Russel Apparels and Ekram Sweaters Ltd.

Mouza- Katali Bhaluka Mymensingh
(24.380522,90.377870)
23 April 2014

Observations

Non-Permitted Additions at East Side of Factory Building

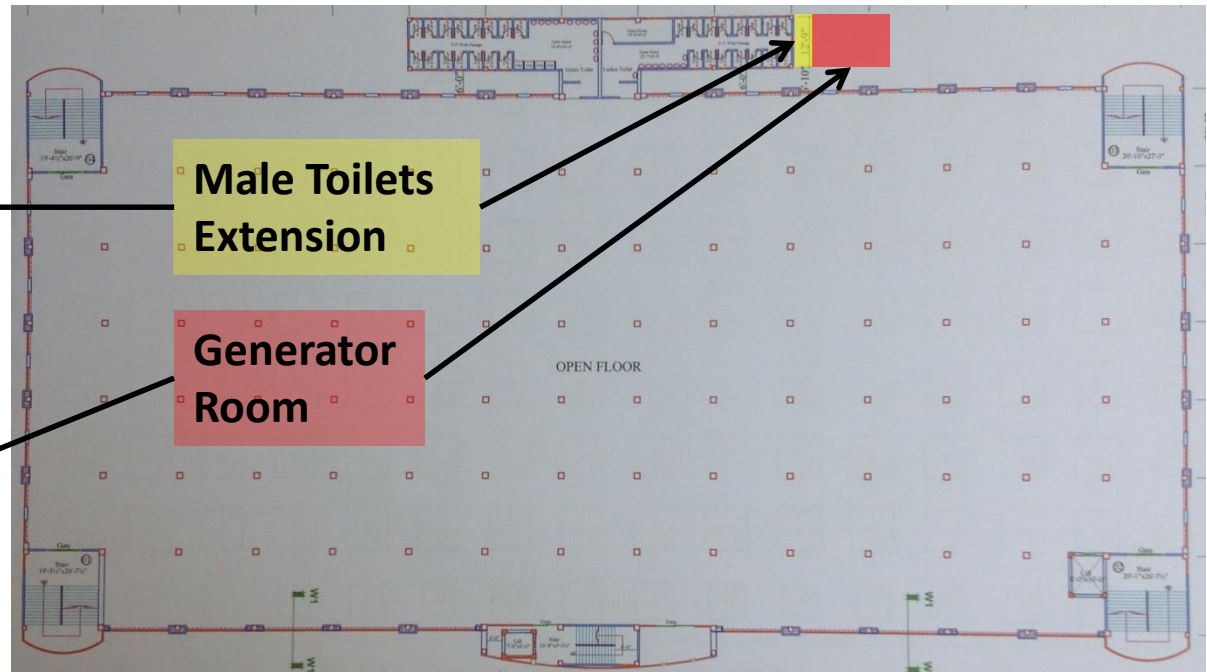
A single-storey generator room has been added to the east side of the building next to the toilets although no permit was provided. Also, construction is on-going for an extension to the male toilets, and no permit was available.

Unfinished Male Toilets

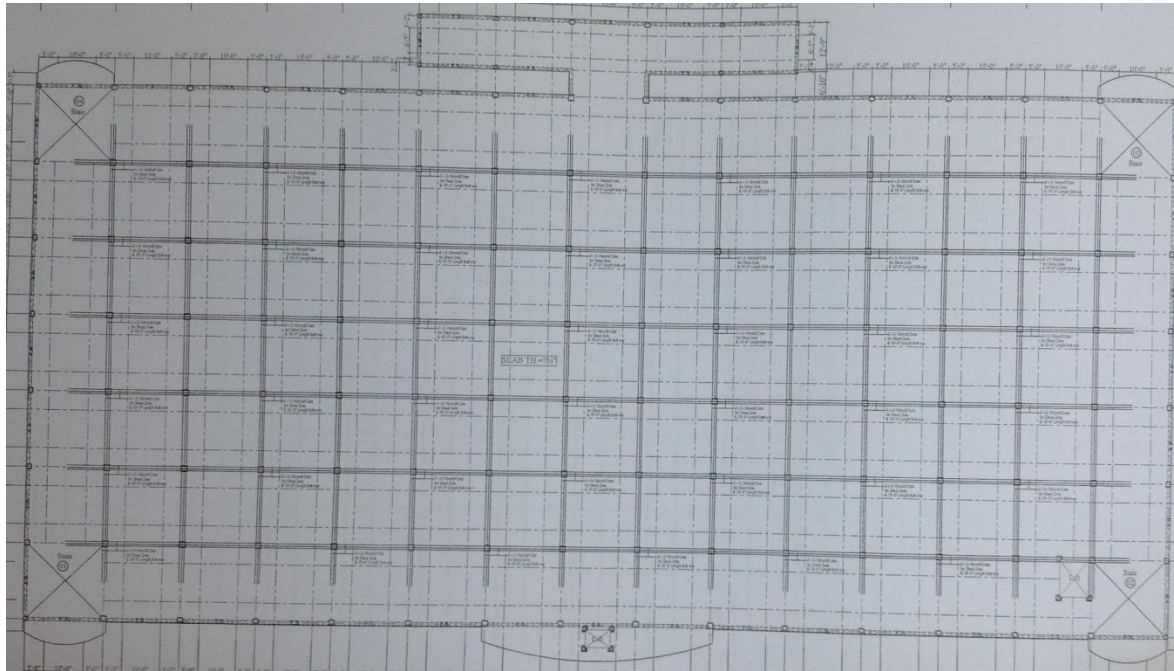
The male toilets are currently under construction, while they are still in use. Appropriate precautions have not been taken to ensure the safety of the factory workers during construction.
